Limited Visual Dam Safety Inspections

OA00020

Opaeula 15 Reservoir

May 2006

Photo 1 Steepened slope near intake entrance.

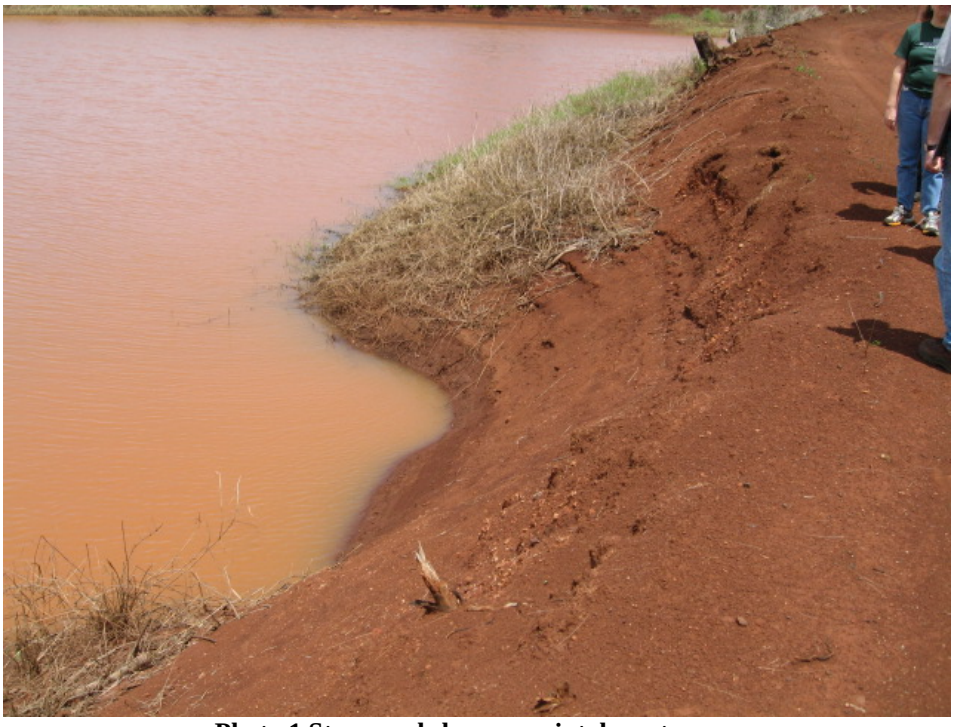
d. Repair gully that extends from crest.
e. Steepened slope at inlet will need to be monitored and repaired if it becomes unstable.

Photo 3 Same as above looking along the crest.

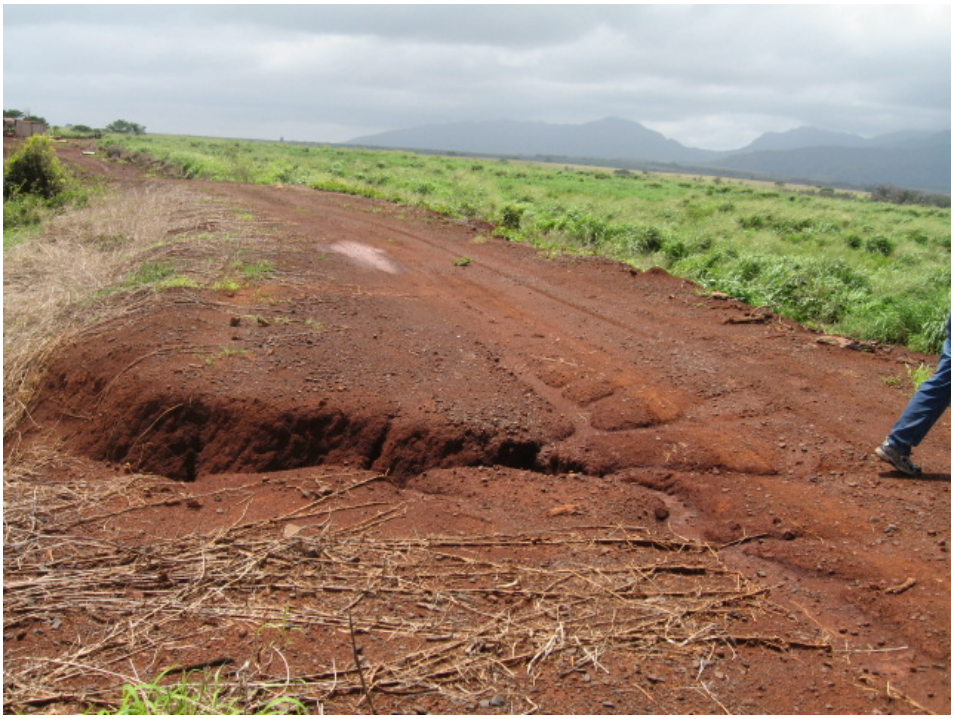
The dam crest was approximately 15 feet wide
There was a dirt access road on top of the crest which appeared to be well utilized.
A major erosion gully was observed, which extends to the upstream slope. The gully is 7 ft long, 5 ft wide, and 4' deep.
Cracks were not observed.
Sinkholes were not observed.
Vegetation was not observed on the crest.

a. The dam crest appeared to be in unsatisfactory condition and not expected to fulfill its intended function. Urgent corrective action is required.
b. Access along the crest was satisfactory.
c. Rut and/or Gully erosion was observed on the crest, which requires maintenance and/or repair. Description: Gully erosion severe and needs to be repaired. This may effect the integrity of the dam at a higher pool. This gully should be excavated first to develop a good surface to place and compact fill. The fill needs to be graded to drain away from the US slope.

If yes, please describe the options for corrective action.
The gully should be cleaned by excavation and then backfilled with the appropriate material and properly compacted.

Photo 4 Upstream slope.

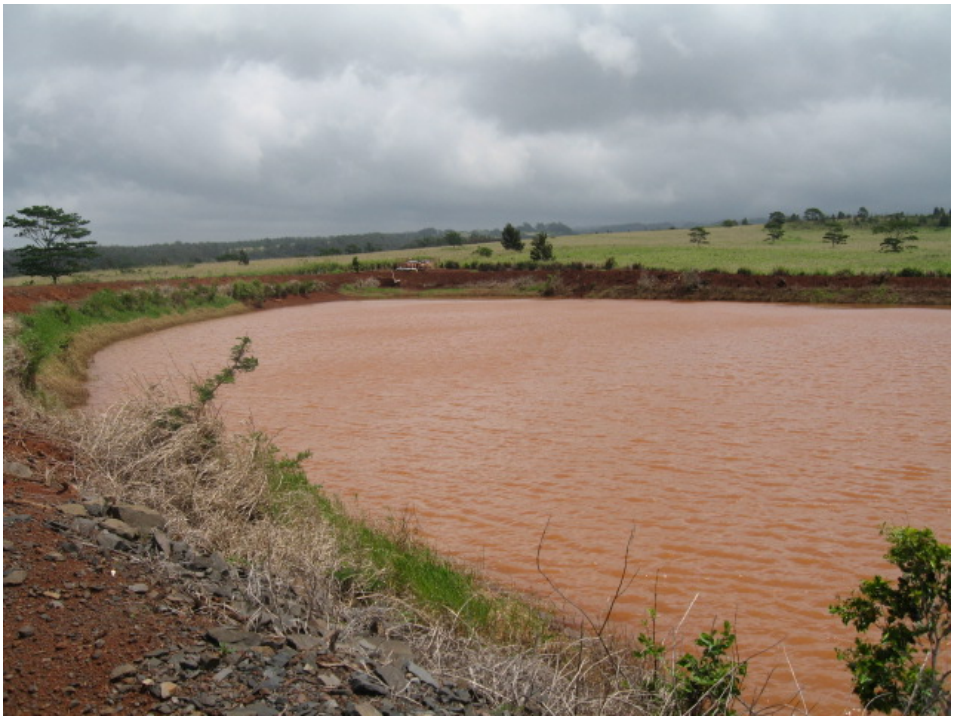
a. The upstream slope appeared to be in fair to poor condition and requires corrective action.
b. Rut and/or Gully erosion was observed on the slope, which requires maintenance and/or repair. Description: Regrade and repair ruts. Establish low vegetation to prevent erosion.
c. Tree(s) were observed on the dam embankment. Trees have been identified as the probably cause of piping failures, and can possibly cause sever damage to the embankment if they are uprooted during a high winds. Corrective action is required to remove the tree hazards from the dam. Acceptable remedies include removal of the tree and its root structure down to a 2” diameter and reconstructing the damaged embankment section. All repair work shall be

Photo 10 Downstream slope, dense vegetation.

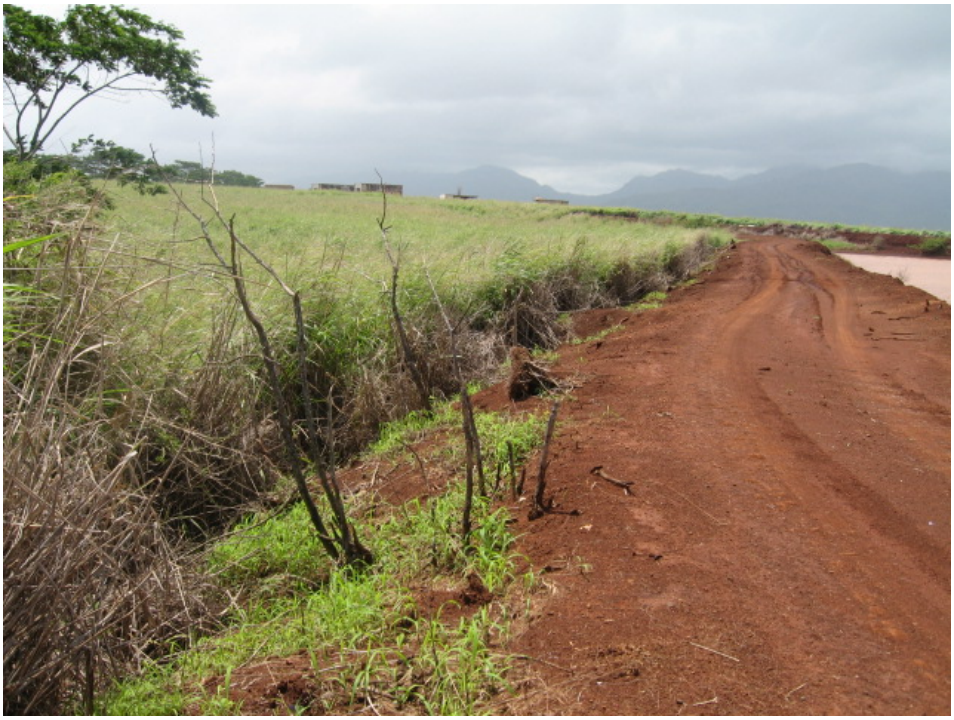
a. The downstream slope was not inspected.
b. The downstream slope appeared to be in fair to poor condition and requires corrective action.
c. The down stream slope was not visible due to high grass and bush vegetation. Clear high vegetation and maintain low to enable easy visual inspection.
